APPLICATION NO.	FILING DATE	FIRST NAMED INVENTOR	ATTORNEY DOCKET NO.	CONFIRMATION NO.
10/761,379	01/22/2004	Hisatoshi Yamauchi	032181	2423
38834 7590 07/12/2007 WESTERMAN, HATTORI, DANIELS & ADRIAN, LLP 1250 CONNECTICUT AVENUE, NW SUITE 700 WASHINGTON, DC 20036			EXAMINER	
			BRADEN, SHAWN M	
			ART UNIT	PAPER NUMBER
Whoming	, , , , , , , , , , , , , , , , , , , ,		3781	
•			MAIL DATE	DELIVERY MODE
		•	07/12/2007	PAPER

Application No.	Applicant(s)			
	10/761,379	YAMAUCHI, HISATOSHI			
Office Action Summary	Examiner	Art Unit			
	Shawn M. Braden	3781			
The MAILING DATE of this communication appears on the cover sheet with the correspondence address Period for Reply					
A SHORTENED STATUTORY PERIOD FOR REPLY IS SET TO EXPIRE 3 MONTH(S) OR THIRTY (30) DAYS, WHICHEVER IS LONGER, FROM THE MAILING DATE OF THIS COMMUNICATION. - Extensions of time may be available under the provisions of 37 CFR 1.136(a). In no event, however, may a reply be timely filed after SIX (6) MONTHS from the mailing date of this communication. - If NO period for reply is specified above, the maximum statutory period will apply and will expire SIX (6) MONTHS from the mailing date of this communication. - Failure t

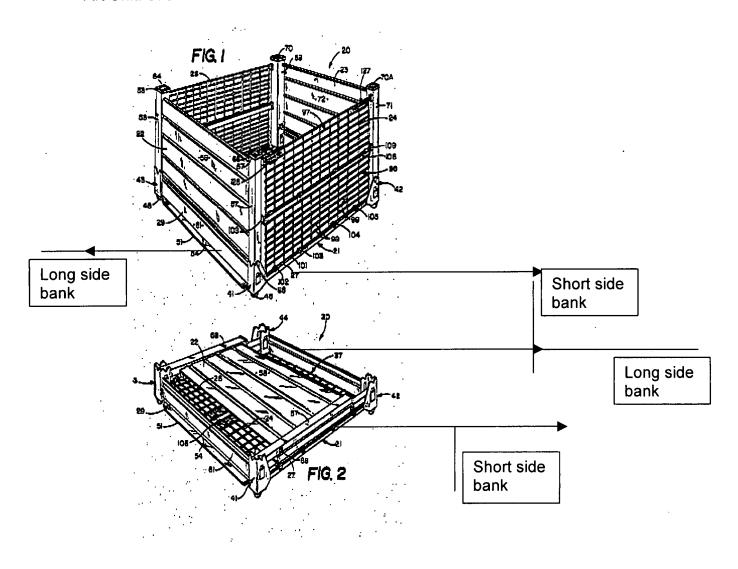
With respect to claim 1, Anderson shows a long-side (61) higher than a short-side bank (27), a bottom fitting portion (51,52), and protruding portions (41,42,43,44), and fitting concave portions (64,67,70,70a).

- 6. Applicant argues that Anderson does not disclose a structure wherein long-side bank portion of the bottom of a large folding container are configured to be higher that short-side bank portion of the bottom. Examiner above has drawn lead lines to figures 1&2 of Anderson more clearly point to the short side and the long side. It can be clearly seen that the long-side bank portion of the bottom of a large folding container are configured to be higher that short-side bank portion of the bottom.
- 7. In response to applicant's next argument that Anderson does not disclose "concave portions" the examiner views "concave" in this case as hollowed inwardly, and Anderson's concave portions (64,67,70,70a) certainly meets that interpretation.
